CASE #09-T- 0073 NOI; AGRICULTURE COMMENTS AND RECOMMENDATIONS

**Subject:** **Case 09-T-0073 Chesapeake Appalachia, L.L.C., "SF-503 16" Upgrade and Compressor Stations" NOI; Towns of Varick & Fayette; Seneca County; agriculture comments.**

## **DIVERSION TERRACE PROTECTION AND MAT**

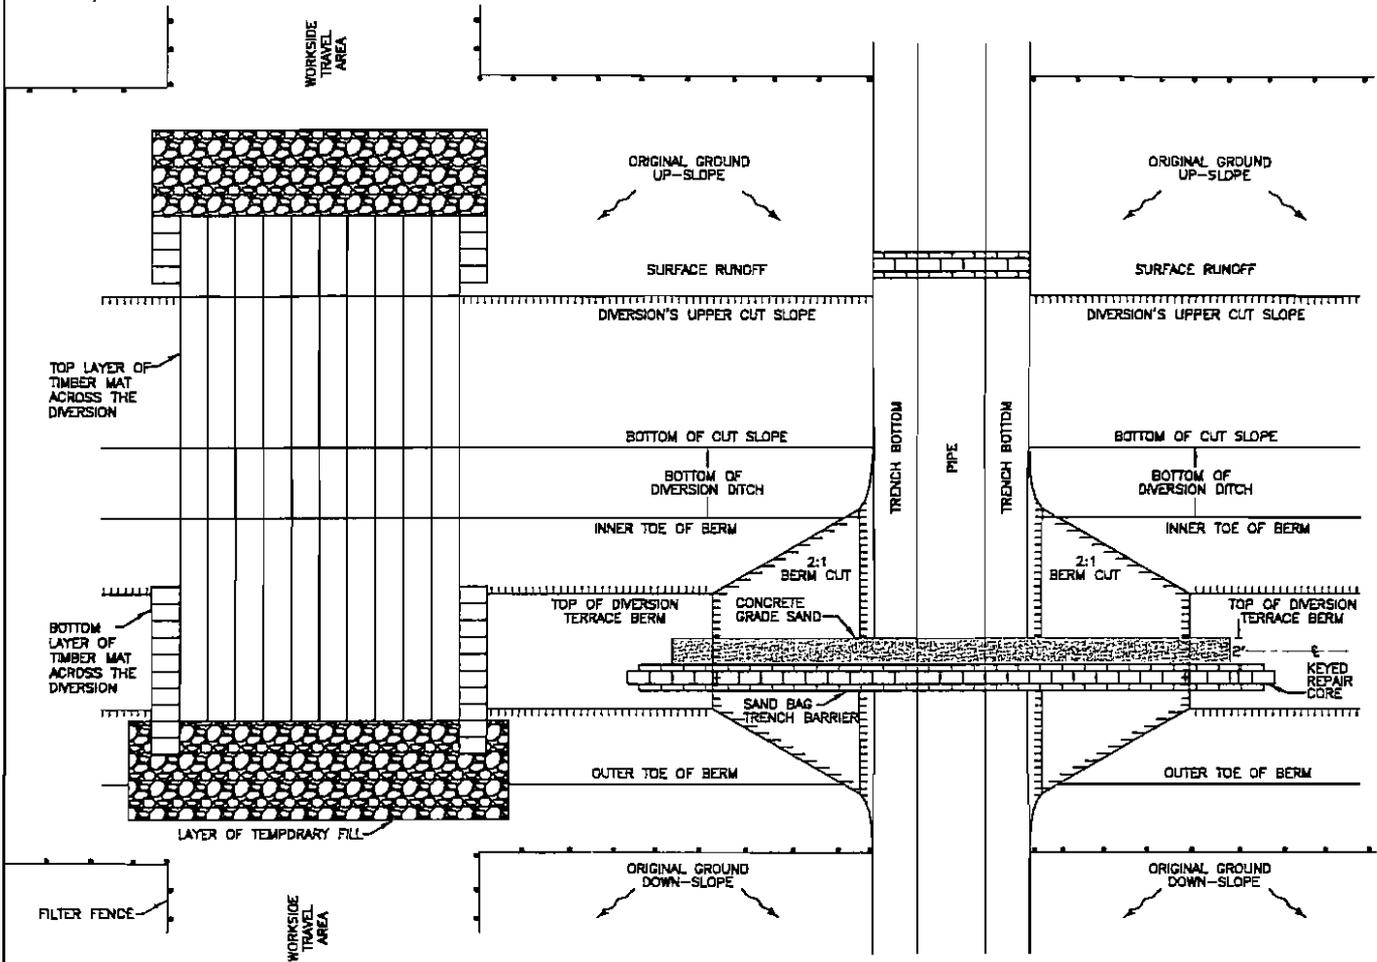
A drainage ditch is present at the CHK existing B. Murray pipeline. Full bentonite breakers are strongly recommended on the upgradient and downgradient ends where the proposed pipeline crosses this drainage ditch. A second drainage ditch was identified in the farm field owned by Jeffrey Trout. Portions of the proposed pipeline that cross these ditches identified throughout the proposed pipeline route will either be Horizontally Directionally Drilled (HDD), or conventionally bored in accordance with the Environmental Management and Construction Standards and Practices Plan (EM&CS&P). In absence of utilizing one of these two methods, and it is determined that the pipeline installation will be "open cut", pipe installation will be conducted in accordance with the construction detail for "Diversion Terrace Repair" (Attachment A) and "Diversion Terrace Protection and Mat" (Attachment B). Burial depth beneath each drainage ditch shall be 60" (48" in all other active ag lands).
